TABLE 3 - COMPARATIVE LIST OF DESIGN CHANGES

R O W	Original Architectural Design	Amended Architectural Design
1	<div>Cover Page</div> <div></div>	<div>Cover page - updated Frenchmans Road streetscape presentation, additional drawings sheets</div> <div></div>
2	<div>DA01 Site Plan</div> <div>Total GFA: 3,785.2m2</div> <div>FSR: 1.397:1</div> <div>Total No. of Beds: 86</div> <div>Total No. of ILUs: 2</div> <div>Total No. of Rooms: 80</div>	<div>DA01 Site Plan Rev B dated 1 June 2021</div> <div>Total GFA: 3,458.4m2 – GFA reduced by 326.8m2</div> <div>FSR: 1.276:1 – FSR reduced by 0.121:1</div> <div>Total No. of Beds: 86</div> <div>Total No. of ILUs: 2</div> <div>Total No. of Rooms: 79 – reduced by 1 room</div>
3	DA02 Site Analysis	DA02 Site Analysis Rev B dated 1 June 2021 – no change
4	DA02a Site Analysis – Location Plan	DA02a Site Analysis Rev B – Location Plan dated 1 June 2021 – no change
5	DA03 Lower Basement Floor Plan	DA03 Lower Basement Floor Plan Rev B dated 1 June 2021 – no change

6	DA04 Basement Floor Plan	DA04 Basement Floor Plan Rev B dated 1 June 2021 – no change
7	<div>DA05 Ground Floor Plan</div> <div></div> <div>Setbacks to 21 Frenchmans Road: 570mm, 1030mm and 10350mm</div>	<div>DA05 Ground Floor Plan Rev B dated 1 June 2021</div> <div></div>

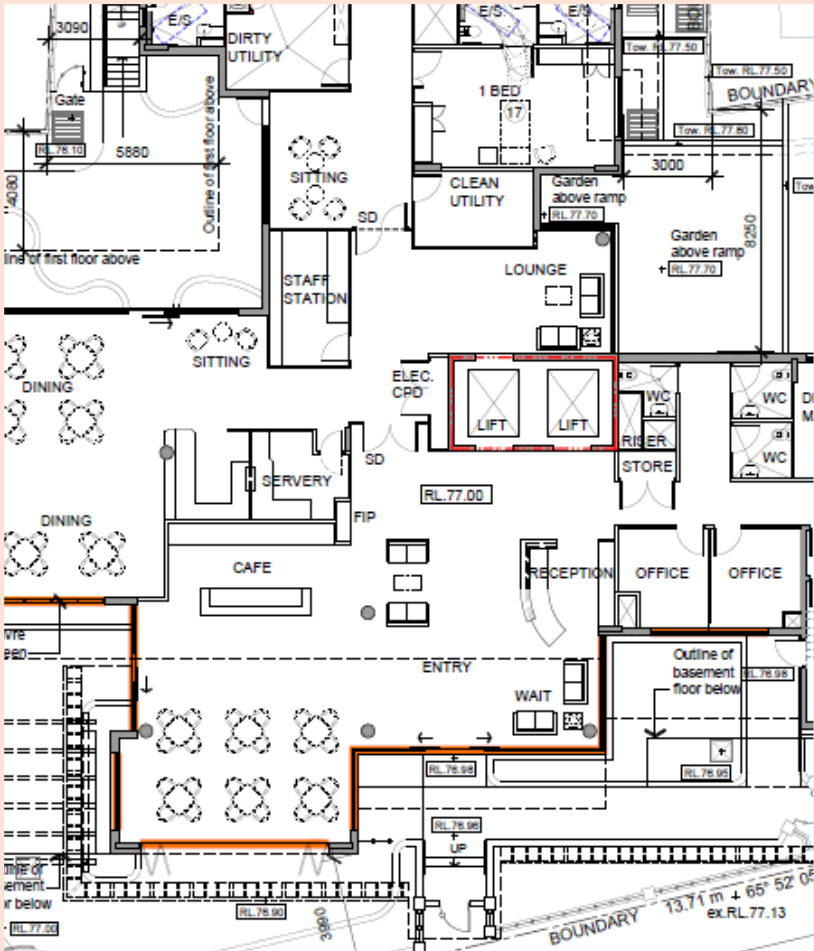
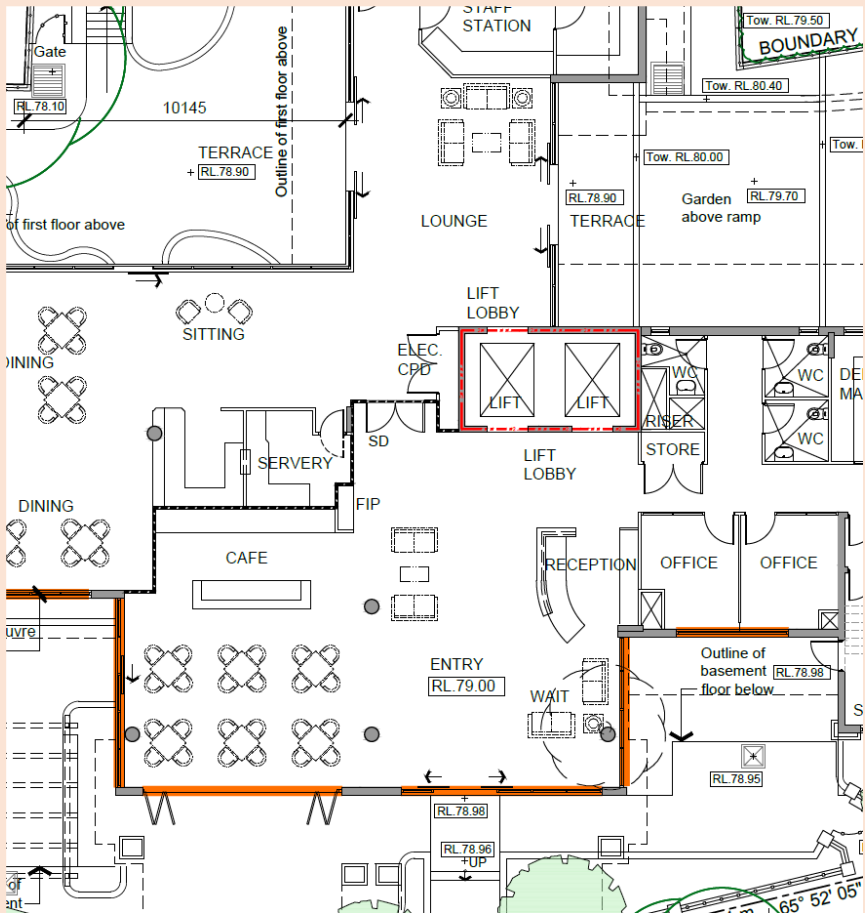
R O W	Original Architectural Design	Amended Architectural Design
	<p>Setback to McLennan Avenue boundary (northern): between 2690mm and 2750mm</p> <p>Setbacks to 25 McLennan Avenue boundary: between 2540mm, 2740mm, 3000mm and 3610mm</p> <p>Setbacks to 27 McLennan Avenue boundary: 2510mm, 3090mm, 3570mm and 6030mm</p>  <p>Setbacks to 23 McLennan Avenue boundary: 10665mm</p> <p>Setbacks to 29 McLennan Avenue boundary: 2510mm</p> <p>Setbacks to 8 Astolat Street boundary: 2375mm</p> <p>Setbacks to 9 Frenchmans Road: 4000mm</p>	<p>Setbacks to 21 Frenchmans Road: no change 570mm, 1030mm and 10350mm - Trellis system over driveway ramp – refer also to amended landscape architectural drawings</p> <p>Setback to McLennan Avenue boundary (northern): no change between 2690mm and 2750mm</p> <p>Setbacks to 25 McLennan Avenue boundary: no change between 2540mm, 2740mm, 3000mm and 3610mm</p> <p>Setbacks to 27 McLennan Avenue boundary: 2510mm, 3090mm, 3570mm and 10140mm enlarged outdoor western terrace with removal of room, reduction in size of utility room; repositioning of staff station; increased glazing windows with inclusion of new doors to create connection between western terrace and eastern terrace via internal lounge area.</p>  <p>Setbacks to 23 McLennan Avenue boundary: 10665mm</p> <p>Setbacks to 29 McLennan Avenue boundary: 2510mm</p> <p>Setbacks to 8 Astolat Street boundary: 2375mm</p> <p>Setbacks to 9 Frenchmans Road: 4000mm</p>

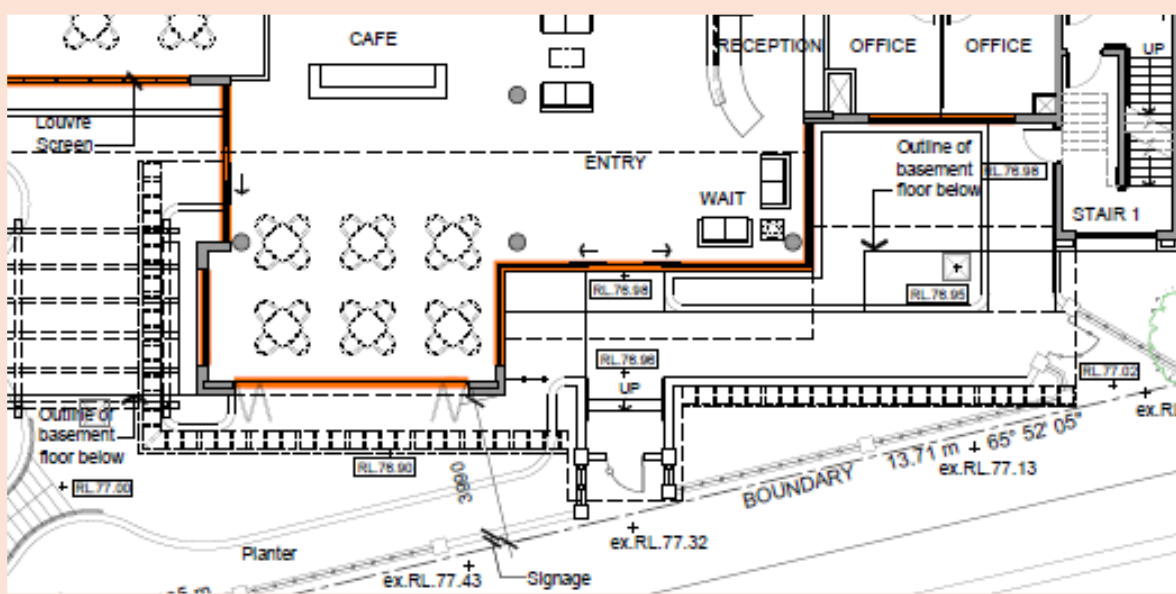
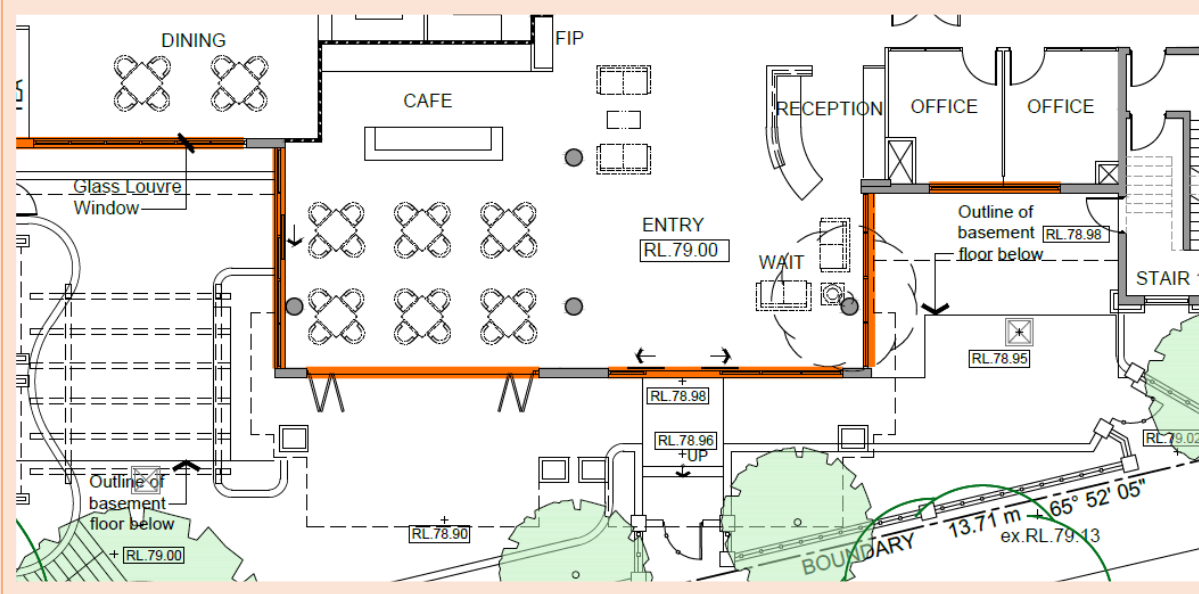
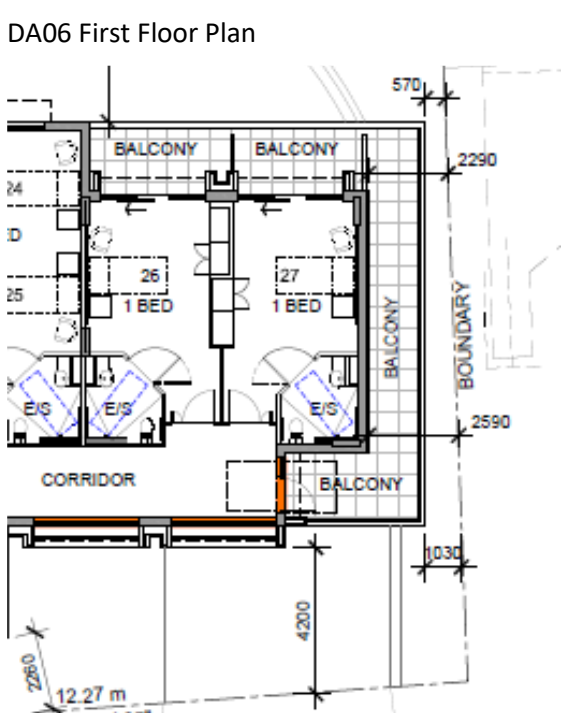
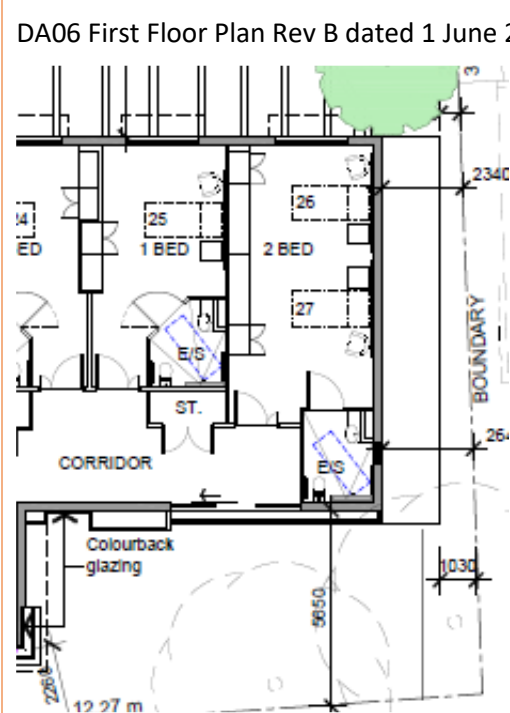
ROW	Original Architectural Design	Amended Architectural Design
	 <p>Setbacks to Frenchmans Road: 2260mm, 3990mm, 5855mm and 7405mm</p>	 <p>Setbacks to Frenchmans Road: 2260mm, 4000mm – 7500mm, 5855mm and 7405mm - increased setback to Frenchmans Road at entrance with reduced lounge area and creation of covered verandah.</p>
8	<p>DA06 First Floor Plan</p>  <p>Setbacks to 21 Frenchmans Road eastern boundary: between 570mm, 1030mm, 2290mm and 2590mm Setback to McLennan Avenue boundary (northern): between 1845mm, 2690mm and 2750mm</p>	<p>DA06 First Floor Plan Rev B dated 1 June 2021:</p>  <p>Setbacks to 21 Frenchmans Road eastern boundary: 570mm, 1030mm, slight increase 2340mm and 2640mm - removal of balconies on eastern first floor level and removed to rooms 26 and 27 Setback to McLennan Avenue boundary (northern): increase between 2645mm, 2750mm and 2890mm – Juliet balcony deleted awning screen inserted</p>

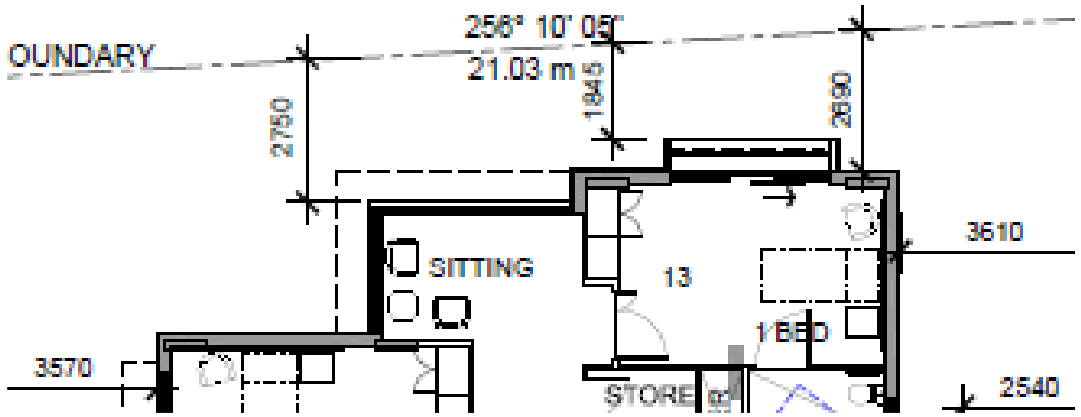
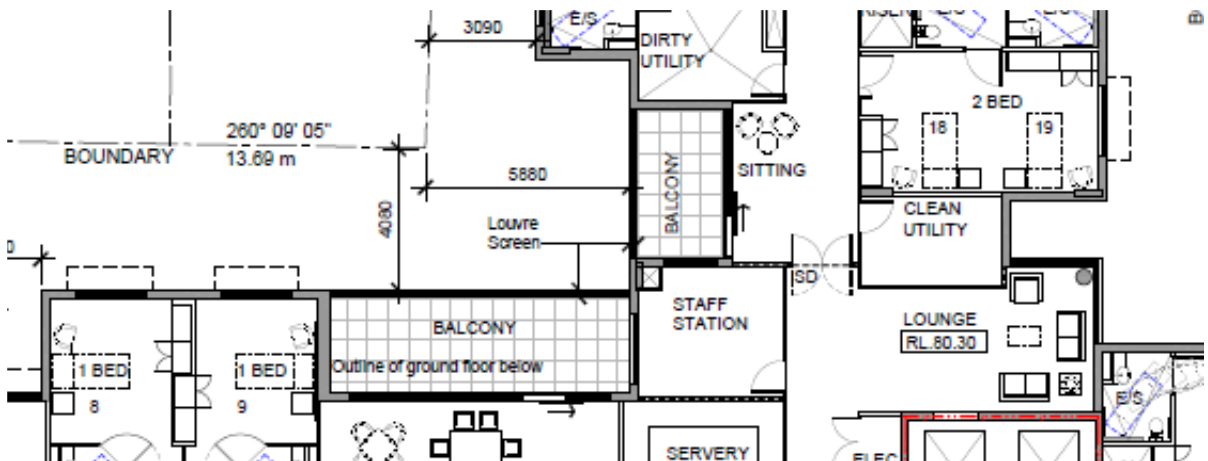
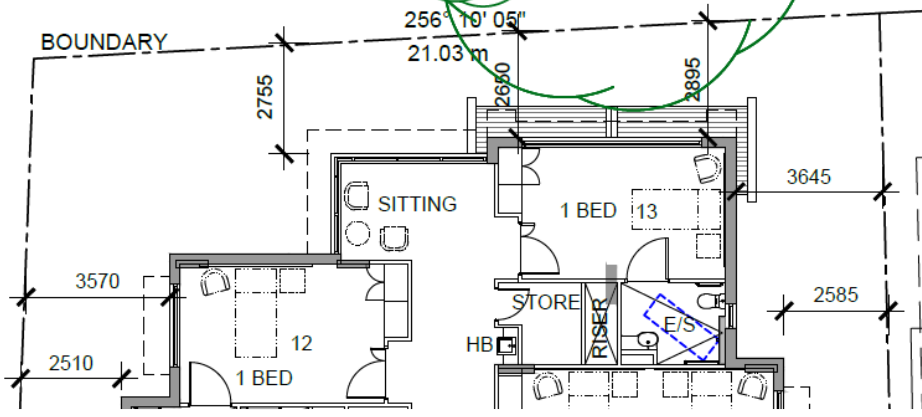
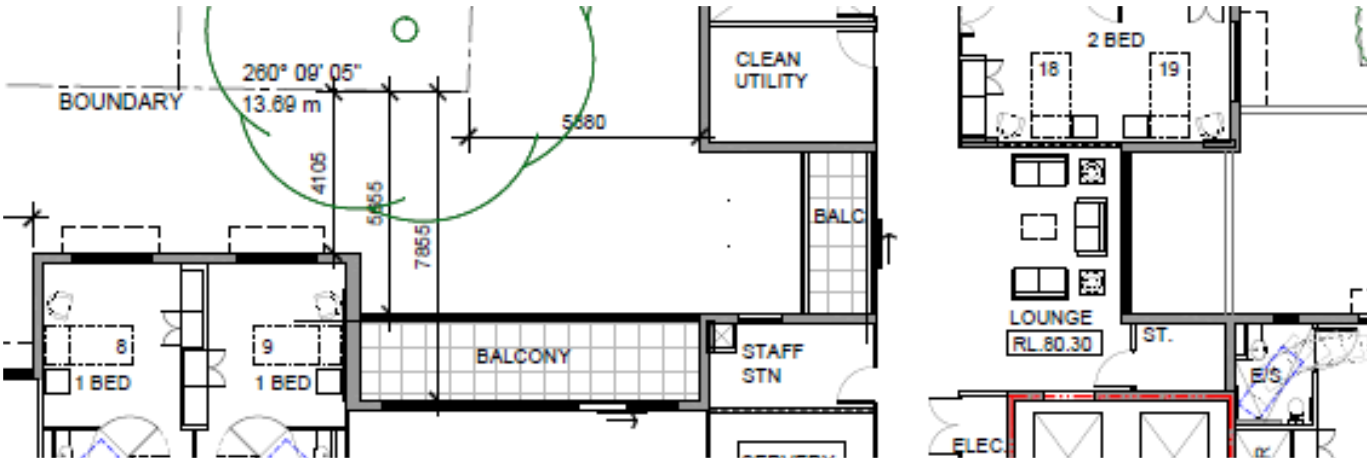
<div> <div>R O W</div> <div>Original Architectural Design</div> </div>	<div> <div>Amended Architectural Design</div> </div>
<div>  <p>Setbacks to 25 McLennan Avenue boundary: eastern between 2540mm, 2710mm and 3610mm and northern boundary 6330mm</p> <p>Setbacks to 27 McLennan Avenue boundary (western boundary): between 2510mm, 3090mm, 3570mm, and 5880mm</p>  <p>Setbacks to 27 McLennan Avenue boundary (northern boundary): between 4080mm and 6080mm</p> <p>Setbacks to 23 McLennan Avenue boundary: 8660mm</p> <p>Setbacks to 29 McLennan Avenue boundary: 4080mm</p> <p>Setbacks to 8 Astolat Street boundary: western boundary 2600mm and northern boundary 2375mm</p> <p>Setbacks to 9 Frenchmans Road: 4000mm</p> <p>Setbacks to Frenchmans Road: between 2175mm, 2260mm, 3500mm, 3990mm, 4200mm, 5230mm, 5855mm, 6600mm, 7190mm and 7405mm</p> </div>	<div>  <p>Setbacks to 25 McLennan Avenue boundary: increased eastern between 2575mm, 2745mm and 3645mm and northern 6335mm</p> <p>Setbacks to 27 McLennan Avenue boundary (western boundary): increased between 2510mm, 3090mm, 3570mm, 5880mm and 10140mm</p>  <p>Setbacks to 27 McLennan Avenue boundary (northern boundary): slight increase between 4105mm, 5555mm and 7855mm</p> <p>Setbacks to 23 McLennan Avenue boundary: no change 8660mm</p> <p>Setbacks to 29 McLennan Avenue boundary: slight increase 4105mm</p> <p>Setbacks to 8 Astolat Street boundary: no change western boundary 2600mm and northern boundary 2375mm</p> <p>Setbacks to 9 Frenchmans Road: no change 4000mm</p> <p>Setbacks to Frenchmans Road: increased 2260mm, 5650mm, 5835mm, 5855mm, 7190mm and 7405mm</p> </div>

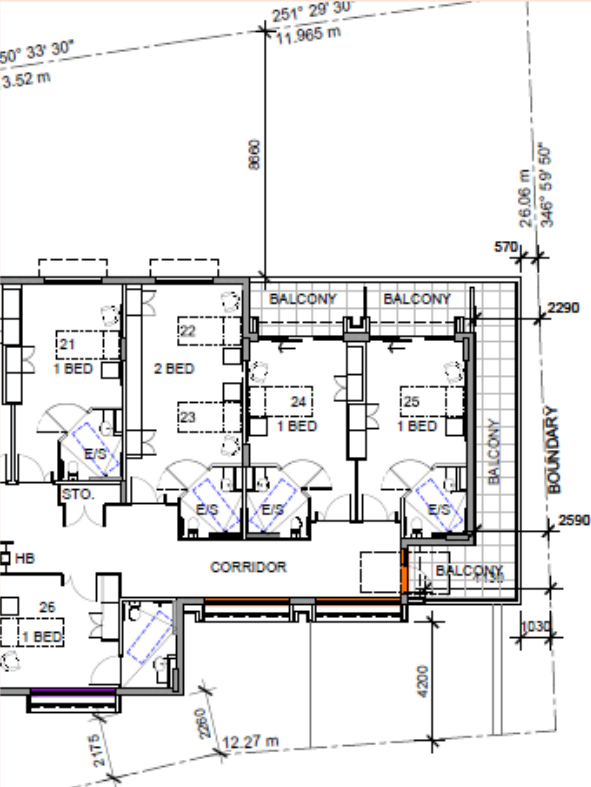
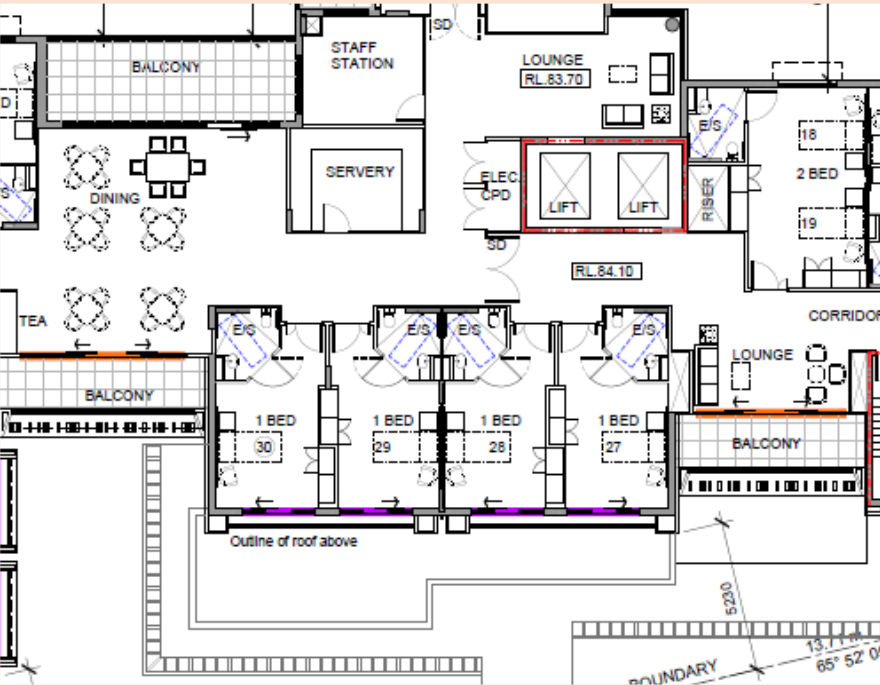
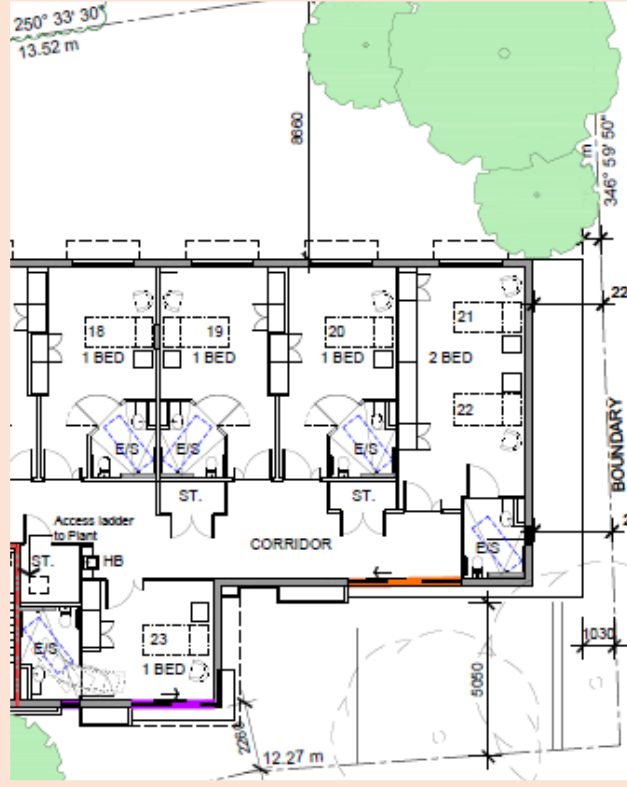
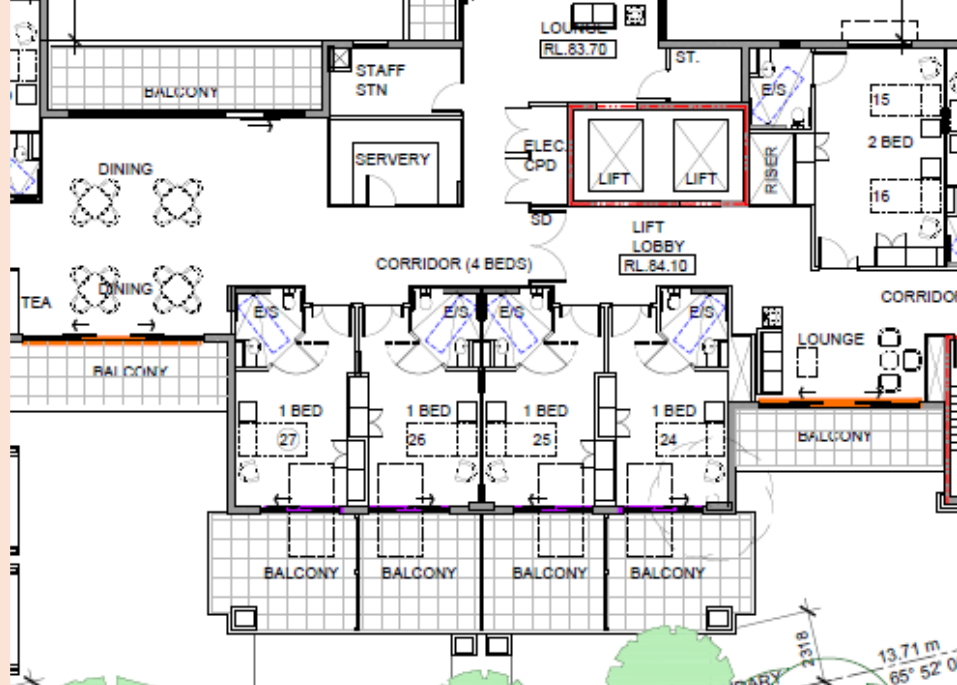
<div> <div> R O W </div> <div>Original Architectural Design</div> </div>	<div> <div>Amended Architectural Design</div> </div>
<div> <div>Eastern “wing” of proposed building – original layout</div>  <div>Central core layout</div>  </div>	<div> <div>Eastern wing balconies removed</div>  <div>Central core layout – introduced balconies to Frenchmans Road elevation</div>  </div>
